Agenda Item # 4 SUB-002796-2023

3B South Subdivision

- Subdivision approval to create two (2) legal lots of record from twenty-eight (28) metes-and-bounds parcels.

DETAIL SITE PLAN

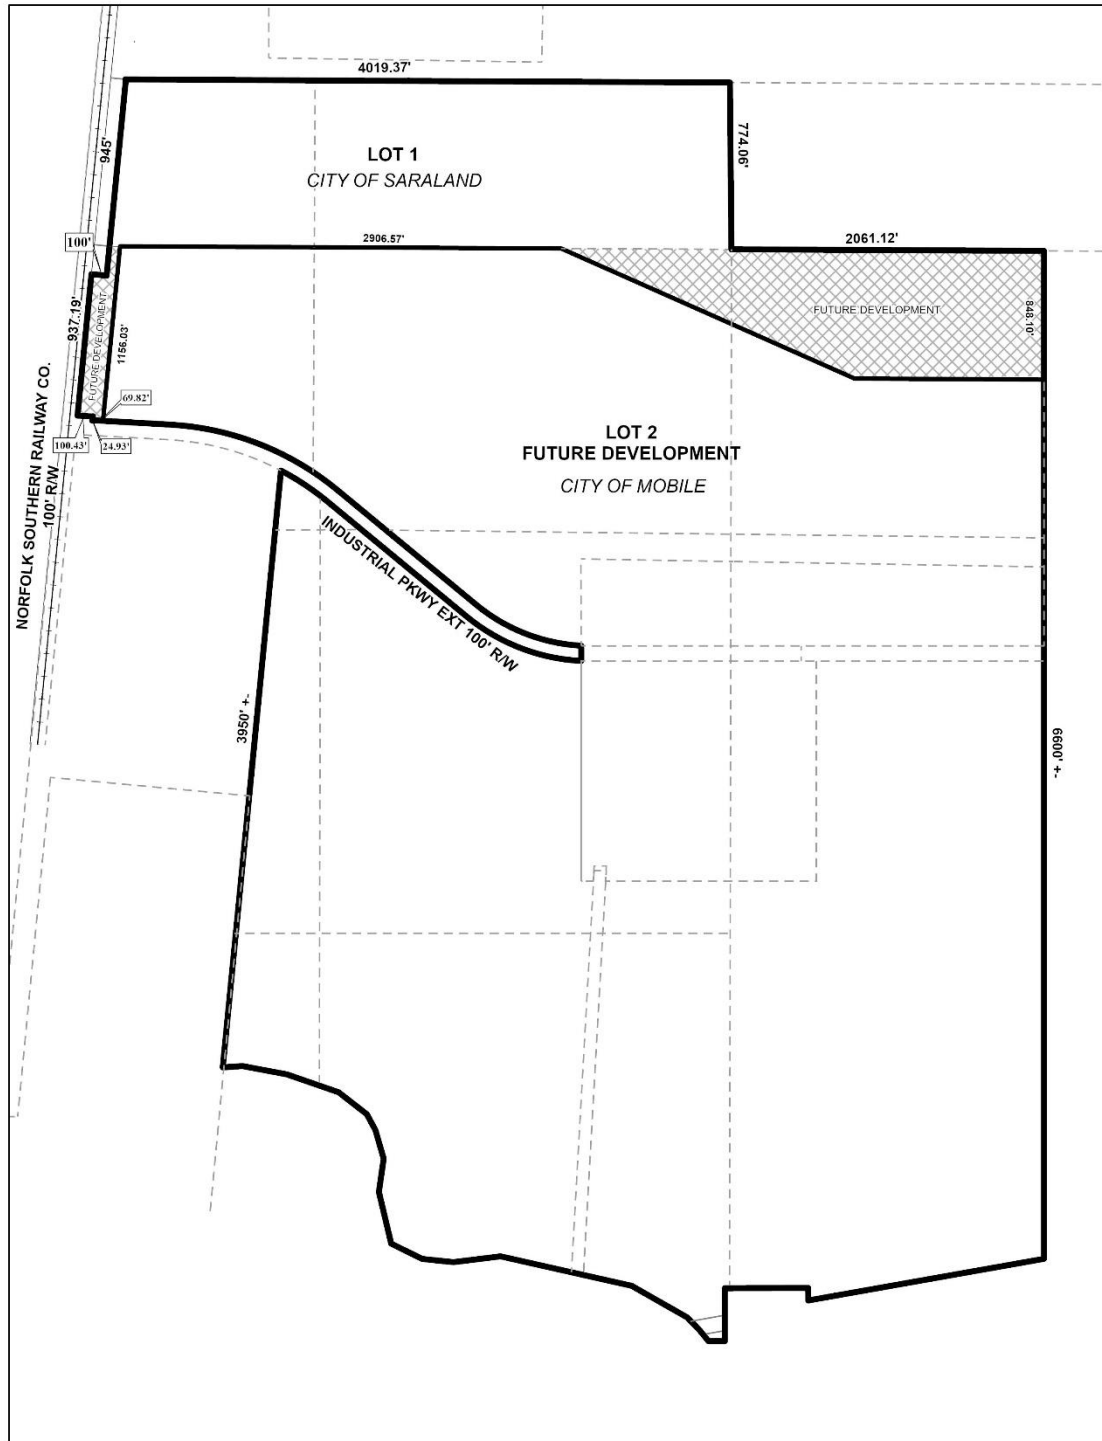
Proposed Lots 1 and 2 have frontage along Industrial Parkway Extension, a minor street without curb and gutter requiring a 60-foot right-of-way. A note on the plat states the street has an existing 100-foot right-of-way, but this is not adequately illustrated. If approved, revision of the plat should be required to illustrate at least a 60-foot right-of-way width along Industrial Parkway Extension.

Both proposed lots exceed the minimum lot area requirements of Section 6.C.2(a) of the Subdivision Regulations; however, neither lot is labeled with its size in either square feet or acres. As such, revision of the plat to provide the size of each lot in square feet and acres should be required, if approved; or, provision of a table on the Final Plat with the same information will suffice.

Each proposed lot is irregularly shaped, and the depth of Lot 1 exceeds its width by more than 3.5, which is discouraged by Section 6.C.3 of the Subdivision Regulations. Such lot designs are not uncommon for larger tract subdivisions, but a waiver of Section 6.C.3. will be required for approval of the request.

If approved, the Final Plat should be revised to illustrate the 25-foot minimum building setback along Industrial Parkway Extension, per Section 64-2-22.E. of the UDC for lots in an I-2 zoning district.

Hash marks are illustrated on portions of Lot 1, with a note indicating they are “fee acquisition areas,” as purchased, or to be purchased, by Norfolk Southern Railway. Another note indicates Lot 1, including the fee acquisition areas, are “Future Development Areas.” Use of the property by the railway is proposed, hence the request to subdivide it from the remaining site that is currently owned by Vertex Refining Alabama, LLC; therefore, the hash marks and the note stating that Lot 1 is a future development area should be removed from the Final Plat, if approved.

As mentioned, a portion of Lot 2 was the subject of Administrative PUD approvals. It should be noted that Article 5, Section 64-5-8.B.2 of the UDC requires any Major Modification to a previously approved PUD to be reviewed by the Planning Commission and approved by City Council. However, Lot 2 is currently labeled as “future development” area on the preliminary plat. As such, modification of the Administrative PUDs is not necessary at this time; however, further development of Lot 2 may require review and approval by the Planning Commission and City Council. A note stating as much should be placed on the Final Plat, if approved.

Finally, as previously stated, a portion of Lot 1 is within Saraland City limits and is not subject to the Mobile City Subdivision Regulations. As such, a similar subdivision request should be submitted to and reviewed by the Saraland Planning Commission, in coordination with this application. If approved, the signature blocks that are required by each jurisdiction should be provided on the Final Plat. Proof that Saraland Planning Commission has approved the preliminary plat (via a decision letter, or signatures for each Saraland signature block on the Final Plat) should be presented to the City of Mobile Planning and Zoning Department, prior to the City of Mobile signing the Final Plat.

1. Revision of the plat to depict the existing right-of-way along Industrial Parkway Extension;
2. Revision of the plat to label the lot sizes in both square feet and acres on the Final Plat, or provision of a table on the Final Plat with the same information;

3. Revision of the plat to illustrate the 25-foot minimum building setback line along Industrial Parkway Extension, per Section 64-2-22.E. of the UDC for lots in an I-2 zoning district;

4. Removal of the hash marks and future development note from Lot 1;
5. Provision of a note on the Final Plat stating future development of Lot 2 may require review and approval by the Mobile City Planning Commission and City Council;

6. Provision of all required signature blocks for both the City of Saraland and the City of Mobile on the Final Plat;
7. Provision of proof that the Saraland Planning Commission has approved the plat, prior to the City of Mobile signing the Final Plat;
